TOWN OF COVENTRY, RI DEPARTMENT OF PLANNING & DEVELOPMENT

STAFF REPORT

Project Name:	Hoxie Court Place				
Plan Type:	3-Lot Minor Subdivision w/ a Street Extension				
Plan Review Phase:	Pre-Application				
Owner/Applicant:	Bruce B. Gibb and Victoria M. Gibb				
Address:	Hoxie Court, Notre Dame Street, and Kernan Court				
Plat / Lot / Zone:	AP 88 Lots 87 and 88.2				
	Zone R-20 Lot Size 9.33 acres				
Existing Use:	Single-family residential unit				
Proposed Use:	Single-family residential unit with 2 additional buildable lots				
Description:	The applicant seeks to merge two existing lots and subdivide them into three new conforming lots. The existing dwelling at 31 Hoxie Court will remain on Proposed Lot 2, which will be 1.24 acres in size. Proposed Lots 1 and 3 will be 0.49 and 0.46 acres in size, respectively, and would be developed with one single-family dwelling each.

TECHNICAL REVIEW COMMITTEE REPORT

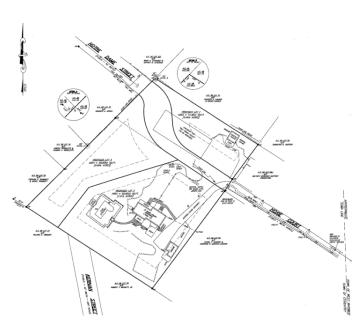
To achieve the required frontage in the R-20 zone, the applicant initially proposed an extension of Notre Dame Street that would culminate in a culde-sac, which would be 188.22' in length. Thus, the cul-de-sac is consistent with Article XIII, Section B.8 of the Subdivision Regulations regarding dead-end streets/cul-de-sacs, which limit their length "to a minimum of one-hundred eighty (180) feet and a maximum of eight-hundred (800) feet." However, this cul-de-sac would be less than 100' from the stub-end of Hoxie Court, and

thus detract from the connectivity of the neighborhood. In addition, the cul-de-sac design would present site access concerns for sanitation and plow trucks as well as fire apparatus.

However, at the suggestion of Staff, the applicant has submitted a draft alternative through-road design at the TRC meeting, which would connect the stub-ends of Notre Dame Street and Hoxie Court. From the Staff's perspective, the through-road would promote neighborhood connectivity. The Department of Public Works and the Central Coventry Fire District have both indicated their preference for the through-road connection, given the concerns about traffic and site access. As designed by the applicant, Proposed Lot 1 would be approximately 0.40 acres in size and have a reduced building envelope. Proposed Lot 2 would be 1.21 acres, a small decrease in size
